Thor Motor Coach Recall Repair Instructions

Recall #	20V-424 2020-338		
Description/Title:	20A/AT Dinette Seatbelt Length		
Affected Product Line(s):	Certain model year 2020/2021 20A/AT Sequence and Tellaro motorhomes		
Service Campaign # :	RC000198	Released Date:	9/11/2020
Repair Code:	Inspect Only: TMCRC80490Y Inspect & Repair: TMCRC80490V	Document Date:	9/11/2020
Time Allowed:	Inspect Only: 0.1 Inspect & Repair: 0.3	Document Revision:	A

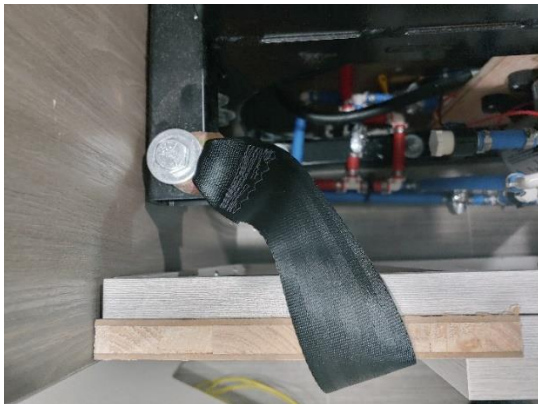
2. Extend the seatbelt all the way out. Measure from the bracket flat along the seat base to end of extension.

If correct seatbelt is installed, this measurement should be at least 45" and no further repair will be needed.

If seatbelt measurement is less than 45", continue to Step 3 for repair procedure.
